March 1, 2019

FROM: Jillian Dierks, Planner, Building & Planning Department

SUBJECT: PRELIMINARY LAND DEVELOPMENT PLAN, 101 N. Merion Avenue, Bryn Mawr College, Bryn Mawr, LD# 3813, Ward 10.

2. Pedestrian Connections & Improvements

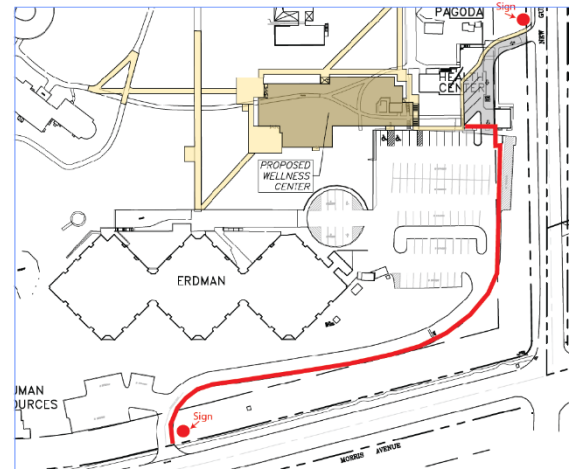
- The applicant shall investigate providing a pedestrian pathway from the lower parking lot adjacent to Erdman Hall to connect to the existing sidewalk along Morris Avenue. If determined feasible, the connection shall be shown on the Preliminary Plan.

Staff met with the applicant on-site to discuss the possibility of making this pedestrian connection. The applicant reiterated concerns related to the impact to slopes, cost and the need for the connection. In our Tentative Sketch Plan review staff indicated that this is an important link in providing a cohesive pedestrian network as this site is located within a half mile of the Bryn Mawr Train Station on the Prioritized Pedestrian Improvement Map that was created as part of the Comprehensive Plan. The site is also within close proximity to several other institutional complexes as well as residential neighborhoods. A new sidewalk will be installed on New Gulph Road along the frontage of the Church of the Redeemer and it is important to add as many links as possible to provide a complete pedestrian network.

Considering the cost, impact to the slopes and the impervious surface limitations, staff recommends the applicant provide one of the following options:

- A. A four foot (4') wide painted pedestrian/bicycle pathway be provided within the existing drive that connects the proposed sidewalk to the lower parking lot adjacent to Erdman Hall to the existing sidewalk along Morris Avenue. The applicant should also provide directional signage at both Morris Avenue and New Gulph Road to indicate that the pathway connects New Gulph Road to Morris Avenue; or
- B. A porous walkway adjacent to the curb line of the existing drive that connects the proposed sidewalk to the lower parking lot adjacent to Erdman Hall to the existing sidewalk along Morris Avenue. The applicant should also provide directional signage at both Morris Avenue and New Gulph Road to indicate that the pathway connects New Gulph Road to Morris Avenue.

In his review, the Township Engineer also noted that pedestrian activity in this area could increase with the proposed development and recommended that flashing warning devices be added or updated at the two existing crosswalks on New Gulph Road.
